Access Compliance Report Public Rights-of-Way (Curb Ramps)

Main Street: TRIAD_LN Cross Street: GAIA_LN Location: SE

ADA ID: RPRK211028115411 Ramp Type: Type 1 - Perpendicular Initial Pass/Fail: Pass Overall Compliance: No Severity Score: 15

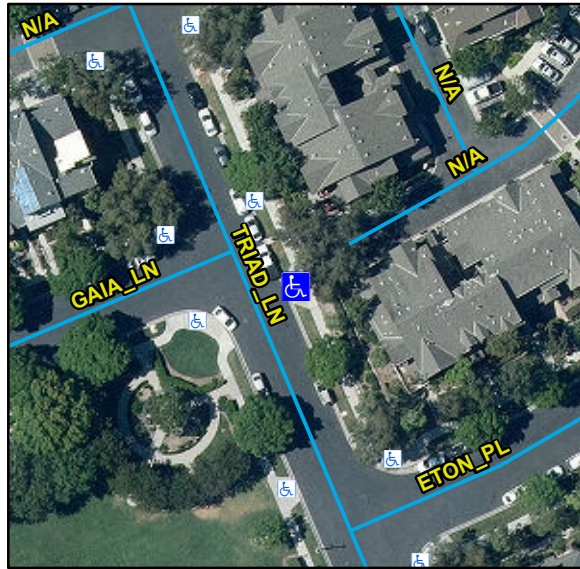
Compliance	Description	Data	Compliance	Description	Data
N/A	Ramp Length (in)	75	N/A	Flare Type LT	
Yes	Ramp Width (in)	54			Sloped
Yes	Ramp Run Slope (%)	8.1	N/A	Flare Slope LT (%)	11.5
Yes	Ramp Cross Slope (%)	1.6	N/A	Flare Traversable LT	No
N/A	Landing Present	Yes	N/A	Flare Type RT	
N/A	Landing Length (in)	60			Sloped
Yes	Landing Width (in)	54	N/A	Flare Slope RT (%)	12.8
Yes	Landing Run Slope (%)	1.7	N/A	Flare Traversable RT	No
Yes	Landing Cross Slope (%)	1.7	No	DWS Provided	No
N/A	Landing Movement Obstructed?	No	N/A	DWS Contrast	N/A
	Landing Movement Type	N/A	N/A	DWS Length (in)	N/A
N/A	Landing Shared	No	N/A	DWS Full Width	N/A
N/A	Clear Space	N/A	N/A	DWS Offset Left (in)	N/A
N/A	Clear Space To Crosswalk (in)	N/A	N/A	DWS Offset Right (in)	N/A
N/A	Marked Crosswalk 1	No	N/A	Marked Crosswalk 2	N/A
	Crossing 1 Direction	W		Crossing 2 Direction	N/A
	Marked Crosswalk 1 Width (in)	N/A		Marked Crosswalk 2 Width (in)	N/A

N/A	Ramp Inside Crosswalk 1	N/A	Yes	Ramp Inside Crosswalk 2	N/A
	Crossing 1 Slope (%)	2.4		Crossing 2 Slope (%)	N/A
	Crossing 1 Cross Slope (%)	2.6		Crossing 2 Cross Slope (%)	N/A
Yes	Gutter Ponding	No	No	Curb Slope	9
Yes	Gutter Lip Height (in)	0		Road Run Slope (%)	N/A
No	Gutter Run Slope (%)	7		Road Cross Slope (%)	N/A
Yes	Gutter Cross Slope (%)	1.5			
Yes	Overall Surface Condition: Acceptable		No	Perp Joint Present	No
	Cross Gutter Present?	No		Spandrel Present?	No
	Replace Cross Gutter?	N/A		Replace Spandrel?	N/A

Remove & Replace Entire Ramp. Remove & Replace Gutter.
